Mayor Meeting

Public Meeting Agenda

28980 – Richard Beckstrand is requesting preliminary plat approval of a 2 lot subdivision. The applicant is proposing to divide the existing property at the subject location to create an additional lot. **Location:** 3809 East Thousand Oaks Circle **Zone:** R-1-10 (Single Family Residential) **Planner:** Spencer W. Brimley

STAFF REPORT

Exhibit "A": November 5, 2014 on site laser measurements by Salt Lake County Assessor

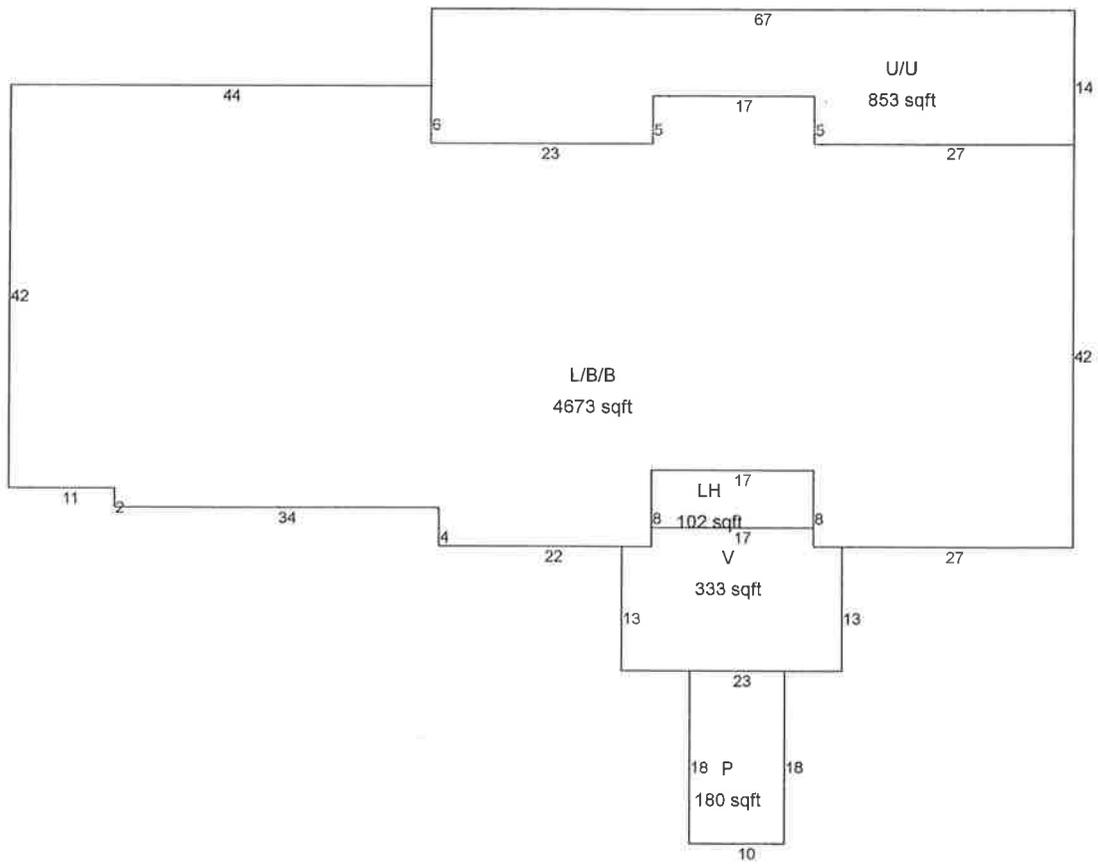
- November 5, 2014 on site laser measurement (5,961 SF) (Exhibit "A")
- Should include additional approximate 97.5 SF from 3 column protrusions on back covered deck, north chimney protrusion, 2 large front pillars protrusions under covered front deck and "lip" on back covered deck (Exhibits "B", "C" and "D")
- Suggests 6,058 building SF (exceeds maximum allowable SF)

Photo illustrating 1 of 3 protruding structural columns on back of residence

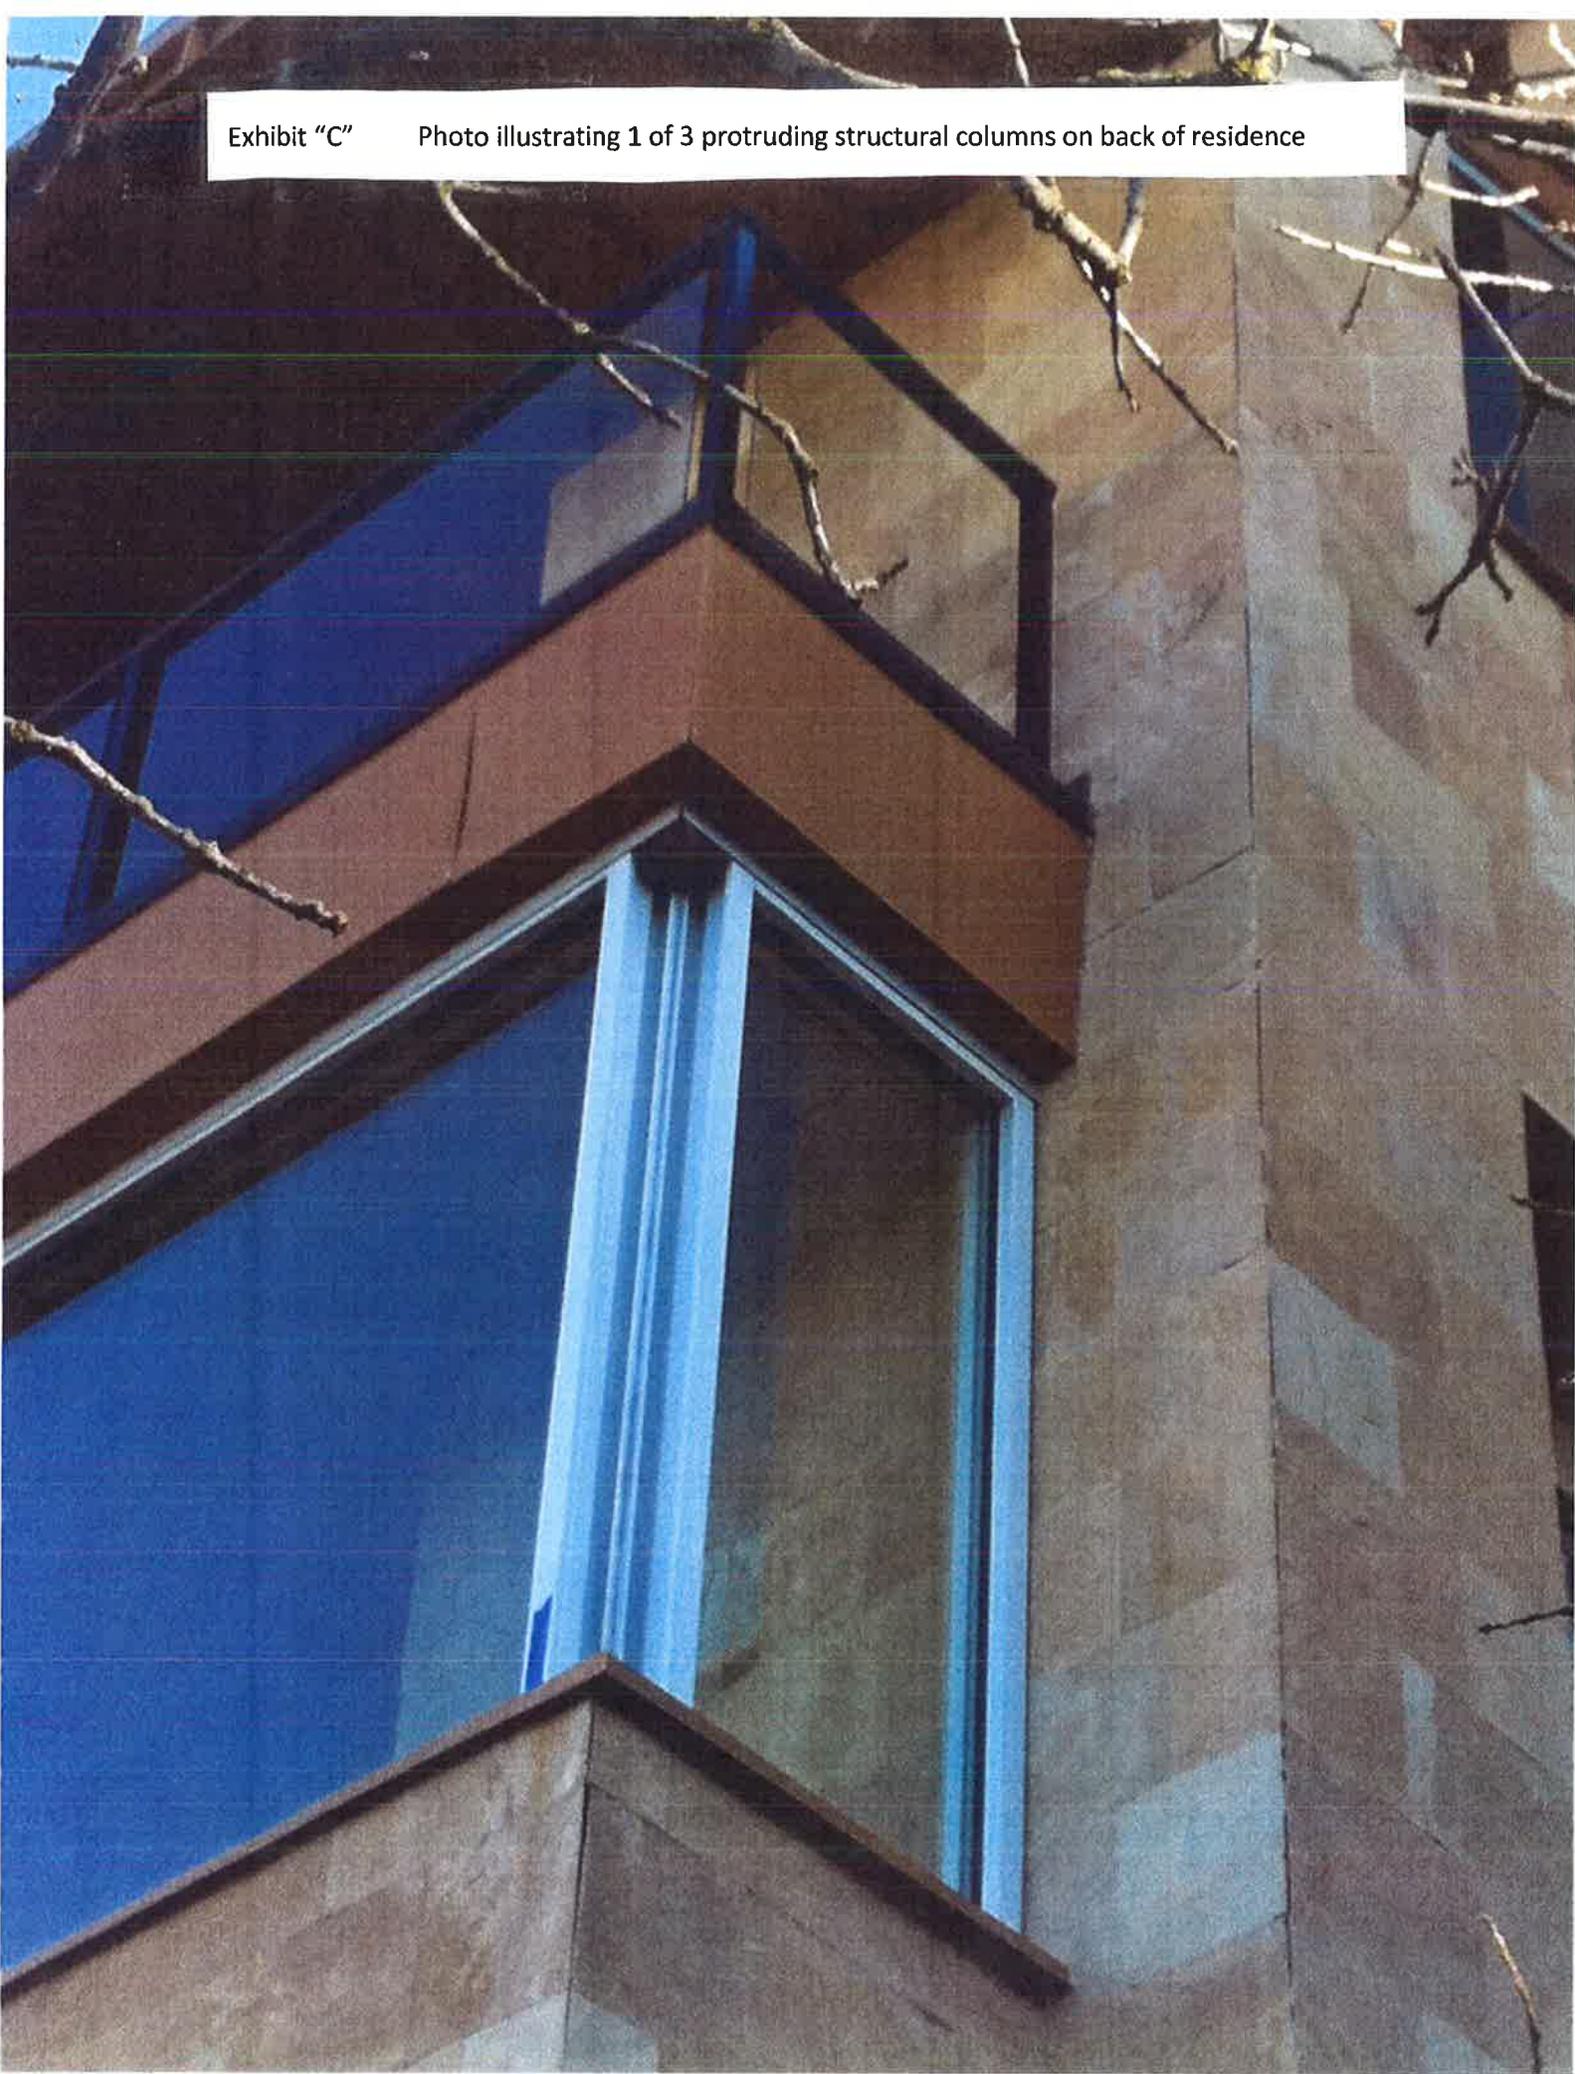
Since the rear covered porch is part of the house then this also needs to be included. When the home was remodeled the porch required a variance. Mr. McWillis ignored the rules and the building code did not enforce it.

Exhibit "D": Photo illustrating magnitude of large structural columns on front covered deck

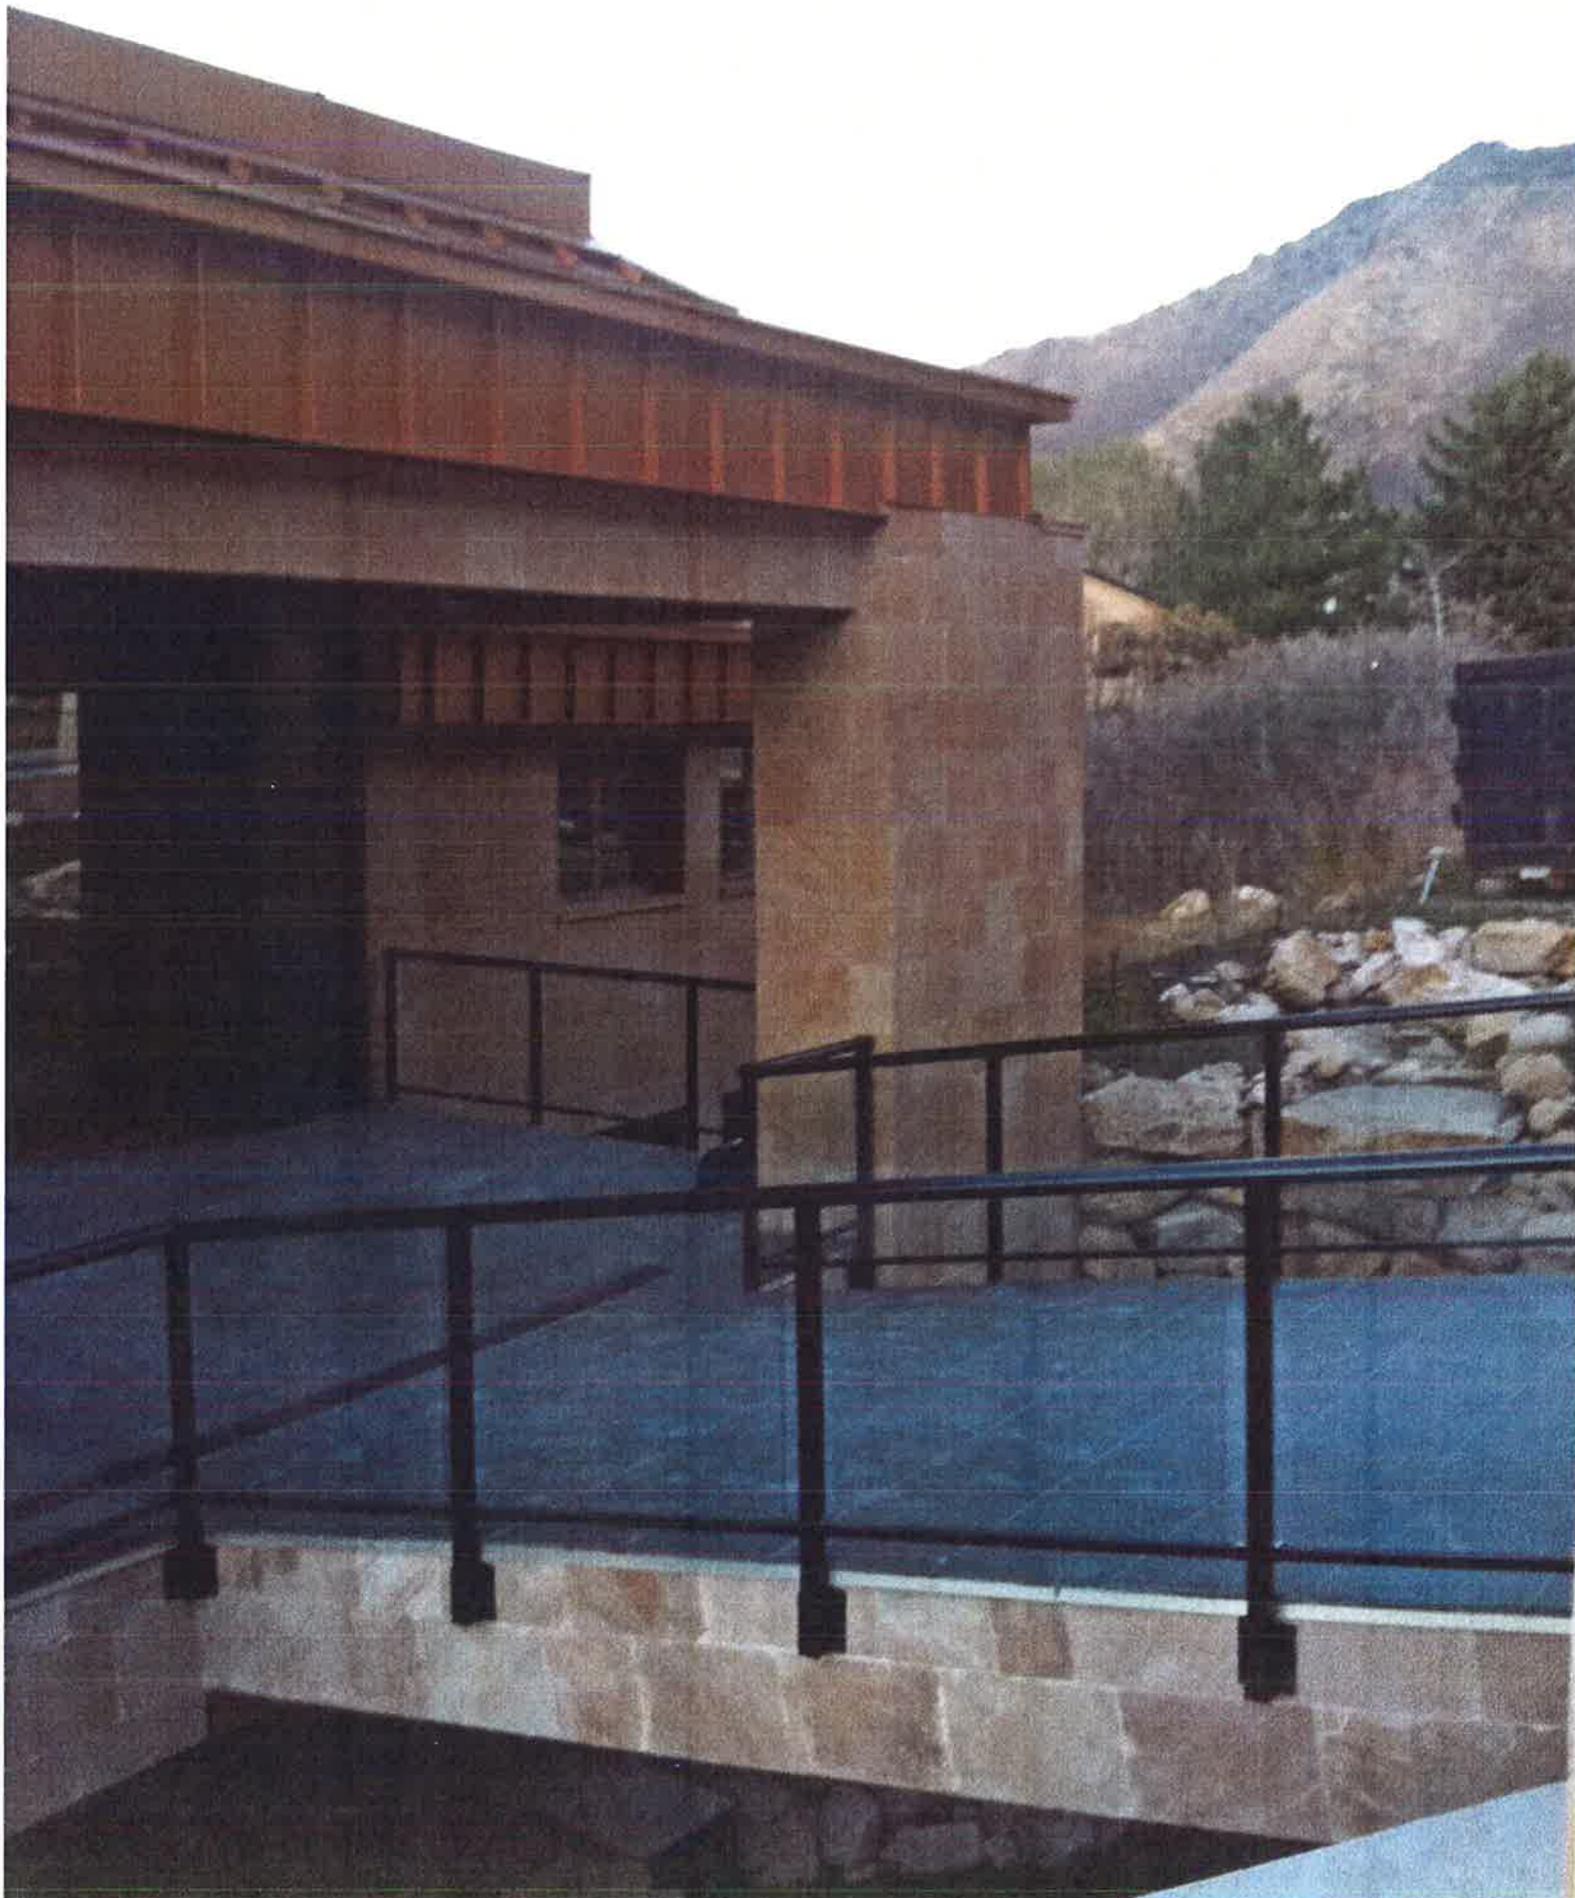
opportunity to at least share the picture of the front porch which you are not including as part of the lot coverage on the ROCZ. This porch needs to be included in the lot coverage.

It is an integral part of the home. The roof skylight and roof is part of the home. The skylight runs from the middle of the home into almost all of the porch roof. This is a solid stone porch with an artificial copper metal roof and glass side walls. It is a definite part of the design of the home.

The front pillars are also in violation.
